UNITED STATES
NUCLEAR REGULATORY COMMISSION
WASHINGTON, D. C. 20555

SUBJECT: IST PROGRAM REVIEW (TAC NO. 65730)

Re: HOPE CREEK GENERATING STATION

ENCLOSURE
HOPE CREEK GENERATING STATION
PUMP AND VALVE INSERVICE TESTING PROGRAM
QUESTIONS AND COMMENTS

10855-P-302(Q)-354

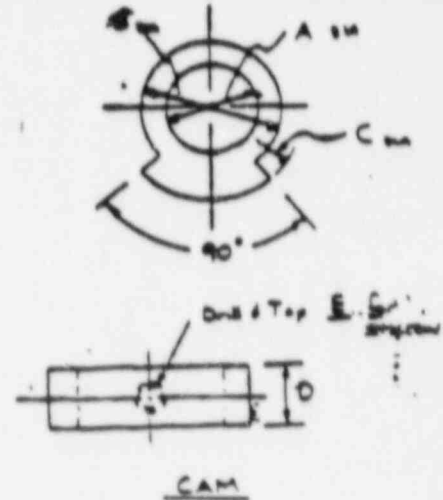
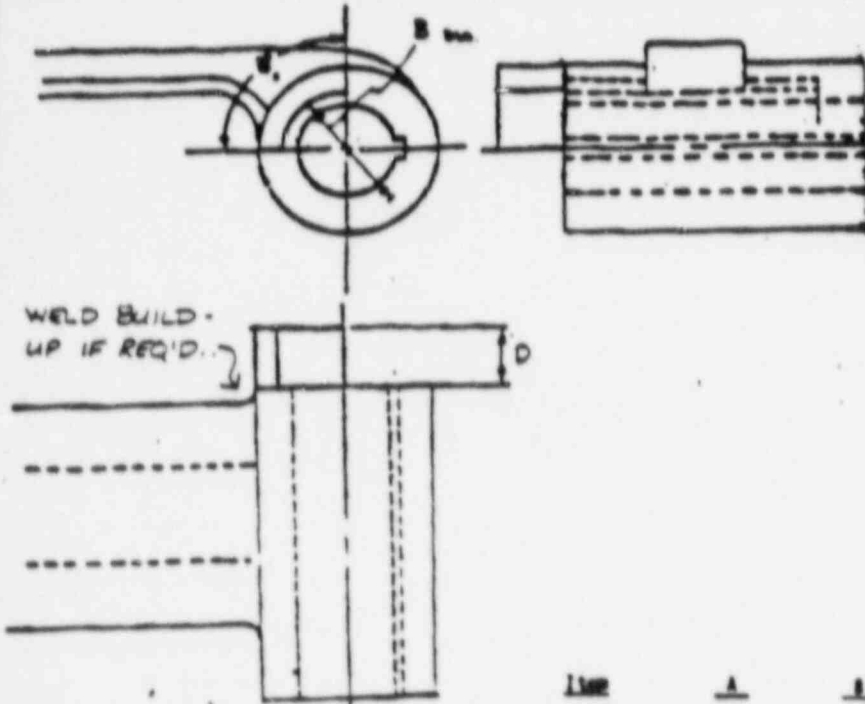
REASON FOR CHANGE: TESTABLE CHECK VALVES WILL NOT OPEN/CLOSE PROPERLY UNDER NORMAL FLOW CONDITIONS

ADD THE INFORMATION SHOWN ON PAGES 3 & 4 TO THE SUBJECT VALVE DRAWINGS. THIS MODIFICATION WILL REMEDY THE TESTABLE CHECK VALVES FROM STICKING IN ONE POSITION.

Item	A	B	C	D	E	Drill Depth vs Ring Pt.
P001-3.1	7/16"	5/8"	13/16"	1/4"	1/8"	1/8"
3.2	1/2"	3/4"	1"	1/2"	1/4"	1/8"
3.3	5/8"	13/16"	1"	1/2"	1/4"	1/8"
7.5	5/8"	13/16"	1"	1/2"	1/4"	1/8"
7.7	5/8"	1-1/8"	1-1/2"	3/4"	3/8"	1/4"
7.9	1"	1-1/2"	2"	3/4"	3/8"	1/4"
7.11	1-3/8"	1-7/8"	2-1/4"	1"	7/16"	3/8"
10.27	5/8"	1"	1-1/4"	1/2"	1/4"	1/8"
P002-7.7	Same as 7.9					
7.13	7/8"	1-1/8"	1-1/2"	1/2"	1/4"	1/8"
THIS ITEM → 7.15	3/4"	1"	1-1/4"	1/4"	1/8"	1/8"

- A. Plus 1/64
- B. Plus 1/8 minus 1/16
- C. Plus 1/8 minus 1/16
- D. Plus or minus 1/16
- E. N/A
- Drill Depth plus 1/16
